Project: **BRISTOL AIRPORT – POST APPLICATION**

Subject: **Detailed Response to NSC comments**

North Somerset Council (NSC) has provided comments, including those by their consultants (Jacobs), on the noise and vibration chapter (Chapter 7) of the Environmental Statement (ES) accompanying the planning application by Bristol Airport Ltd (BAL) for the development of Bristol Airport to accommodate 12 million passengers per annum (mppa) (Application No. 18/P/5118/OUT). The comments were received on 7th February 2019 and discussed at a meeting held on 11th February 2019, which was also attended by Bickerdike Allen Partners LLP (BAP). As BAL's noise consultants and the authors of Chapter 7 of the ES, BAP has prepared responses to the comments which are addressed in this memo. The memo also addresses agreed actions arising from the meeting.

**Figure 7F.2
Residential Receptors
Road Traffic Noise**

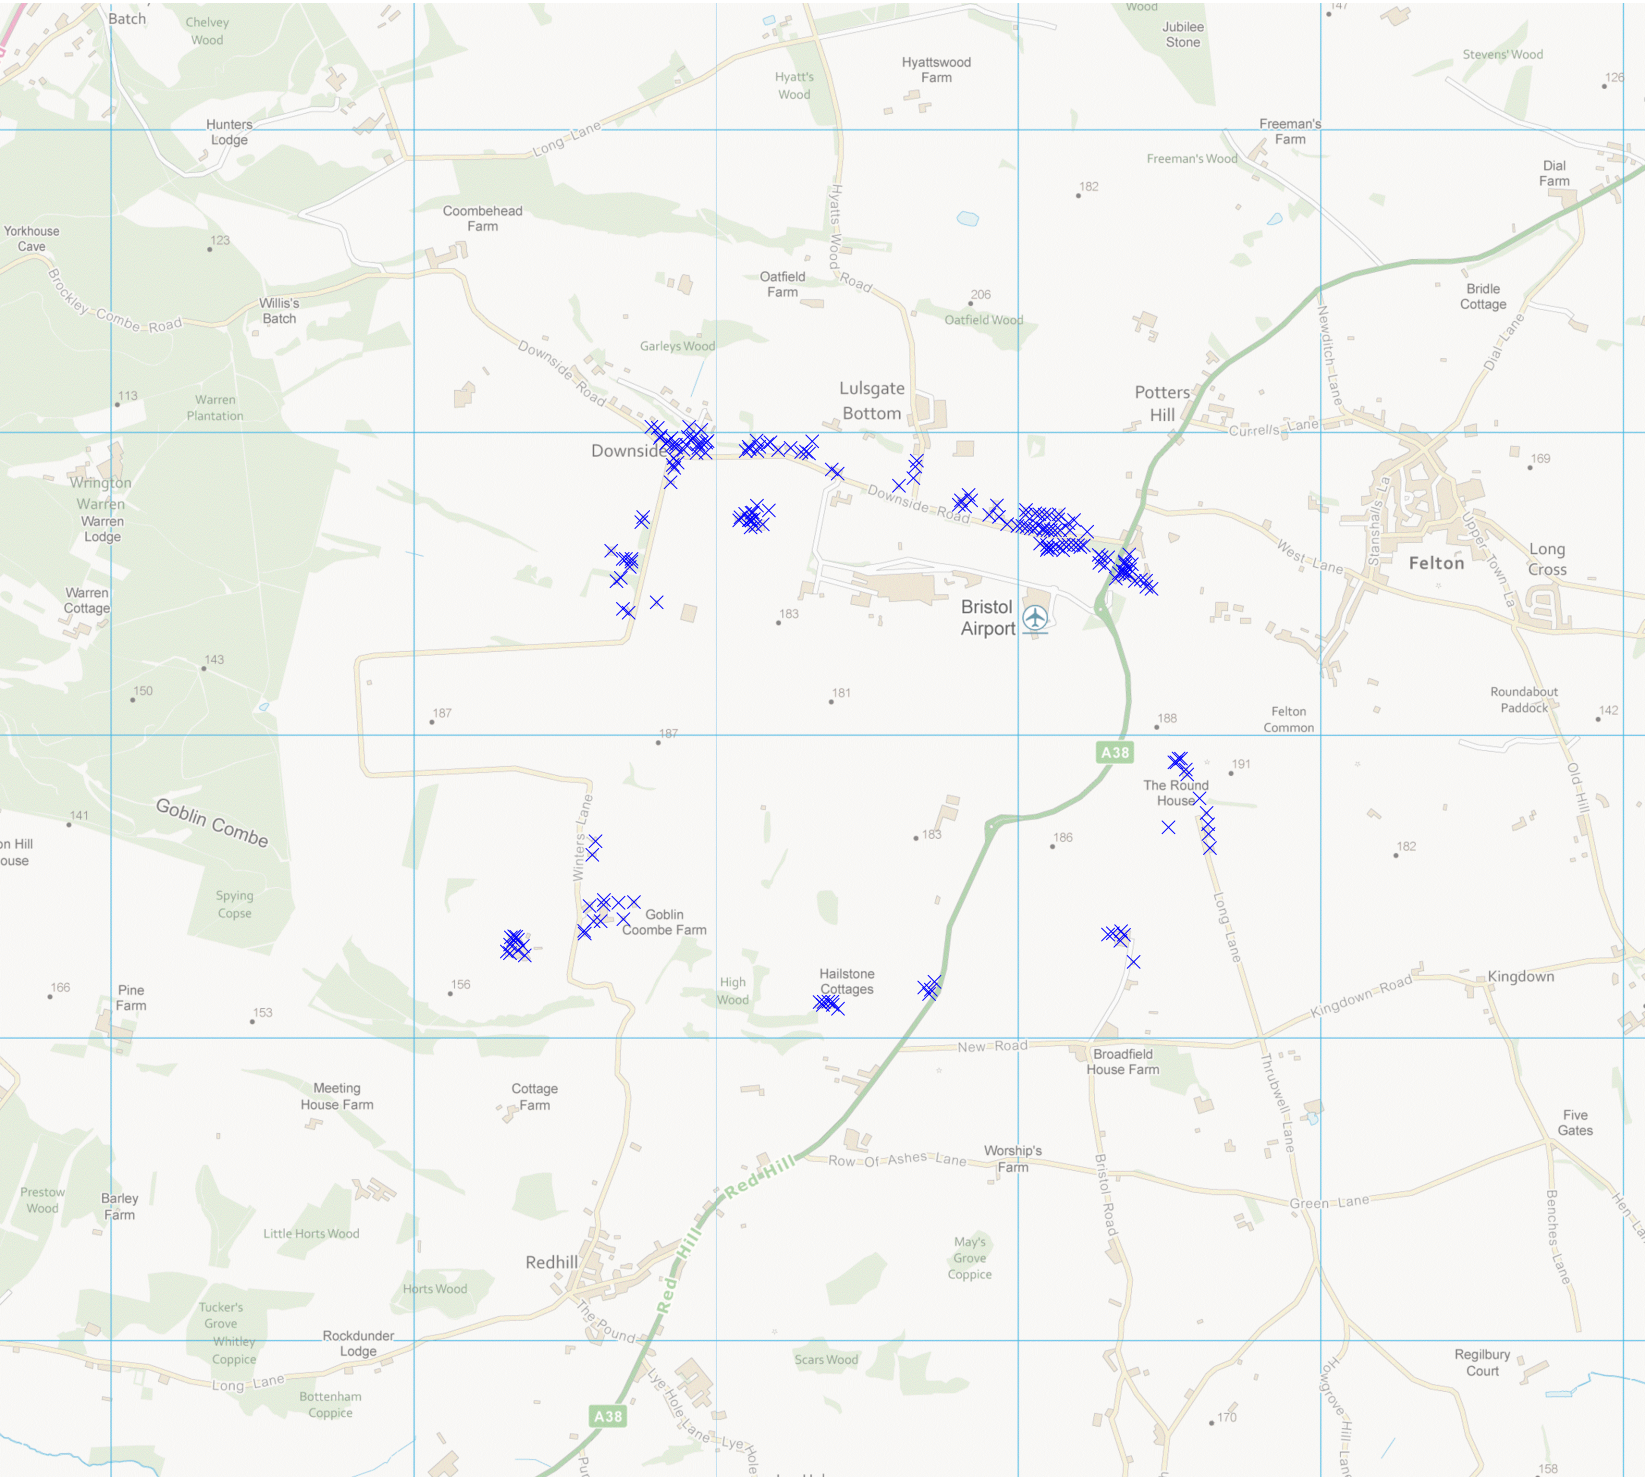
“No explanation is provided on how the study area has been derived. From Figure 7F.2 the study area appears too small to examine possible impacts, as these could be quite widespread and the issue of noise traffic is known to be a concern for local residents. It is considered that residential areas such as Potters Hill and Felton should be considered in the assessment of road traffic noise impacts.”

Figure 1: Cumulative Receptor Locations

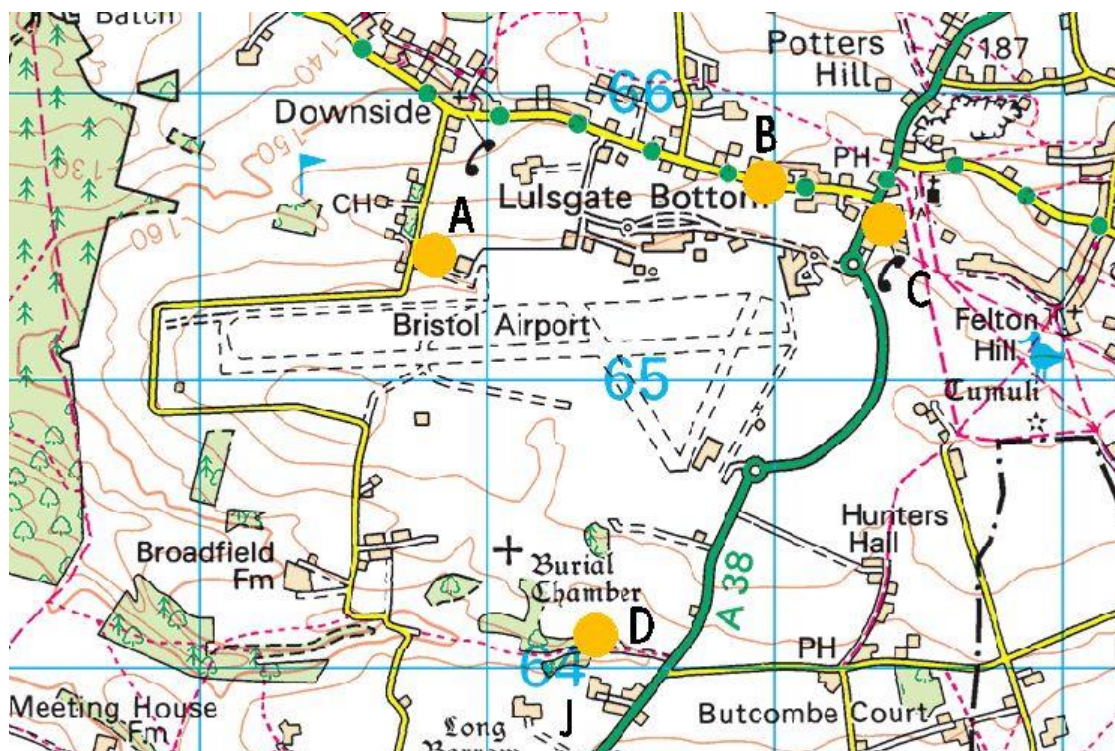
assessments are made of any effects (beneficial and adverse) associated with the Proposed Development. Mitigation measures are also described, where appropriate, as are cumulative and residual effects". It is considered that cumulative effects have not been considered and should have been. Although there is no standard methodology for combining noise sources, it would not be difficult to take a few sample receptors and manually add the predicted noise levels."

The cumulative effects of noise as normally assessed in an ES have been addressed in Chapter 18. It was however agreed at the meeting of 11th February to prepare a table of representative receptors showing the "cumulative" effect of adding predicted levels of air noise, ground noise and road traffic noise. The receptors selected are those which overlap between the "key receptors" assessed in the ES for air and ground noise. Their locations are shown in Figure 1.

The cumulative noise levels at each receptor have then been calculated for daytime and night time separately in Table 4 and Table 5.
